PART 573 Defect and Noncompliance Report

Report Date: February 8, 2005

Make:	Vermeer	Model Years Involved:	2002 - 2005	
Model(s):	BC1400			
Production Dates:	Beginning:	01-28-2002	Ending:	12-06-2004
VIN Range:	Beginning:	1VRU1614821000134	Ending:	1VRU1614151001775
Vehicle Type:	Trailer -- Single axle Brush Chipper

Description which characterizes/distinguishes the recalled vehicles from those model vehicles not included in the recall: The VIN Range includes 1642 units. The trailers affected are fifty-seven (57) units that received an optional, factory-installed tongue for curb-side feed capability (JSK01068).

WELDMENT - TONGUE
SECTION CURSIVE NEED
PART NAME 162615001
REVISED 2/21/02

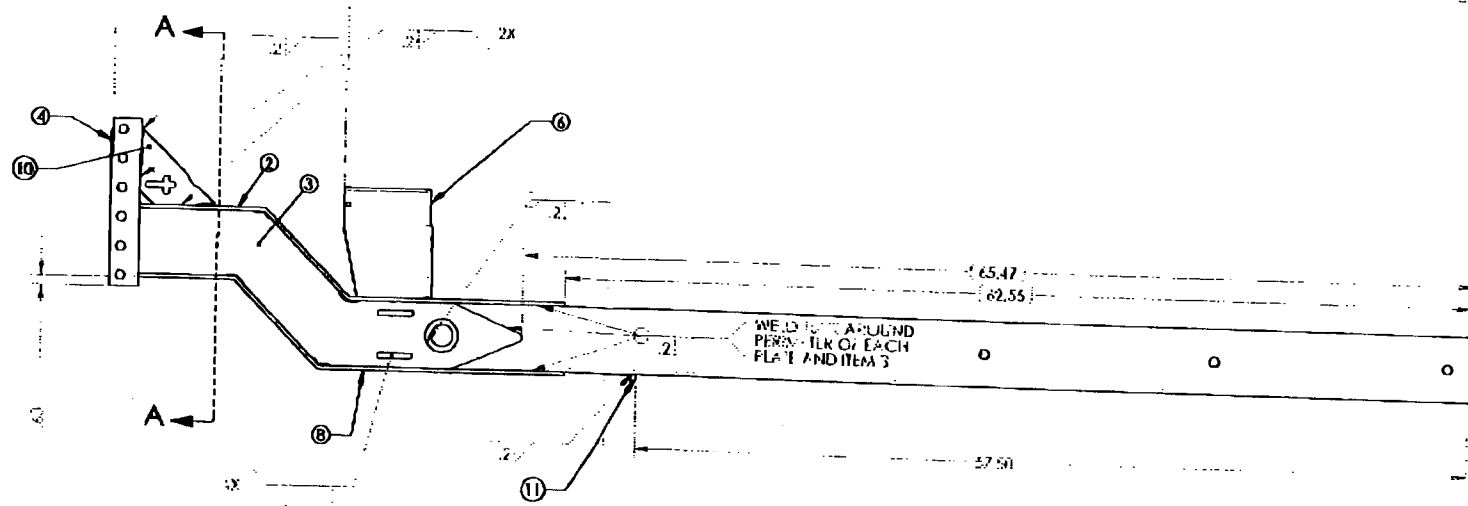
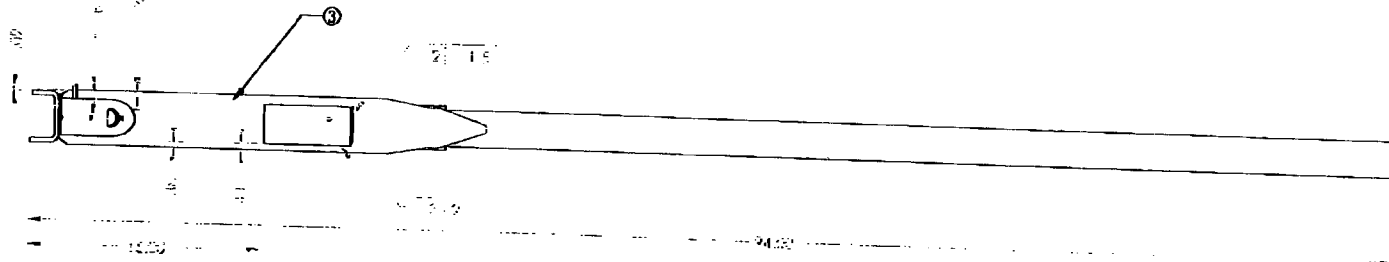
Fatigue cracks can occur in a heat affected zone of the tongue weldment. Recent Finite Element Analysis (FEA) was undertaken after notification of the failure. The analysis indicates that material stresses at the point of failure can result in fatigue fractures (cracks) which can eventually result in complete separation of the tongue.

A copy of a product brochure for Vermeer Model BC1400 is attached. The brochure does not show the curbside feed tongue option, but is shown in the attached Drawing Item Number 162615001, Weldment – Tongue BC1400 Curbside Feed. Also attached are digital photographs of BC1400, VIN 1VRU1614721000366, reference in the chronology below.

Component design had inadequate useful life.

Development of fatigue cracks in the tongue which can result in tongue failure separation from the towed vehicle.

The product group has completed an alternative design for a modified tongue and has completed FEA analysis that confirms that uniform distribution of the loading will occur under the modified tongue design.

Field kit modifications are currently under development. The new tongue design is a bolt-on riser design, which according to the final FE analysis, shows all indications of providing a service life for the riser and its interface with the tongue tube that is equivalent to that of the uninterrupted main forward tube. Confidence in the tube life is based on the test data and presently successful field exposure experienced by the straight tongue model of the BC1400.
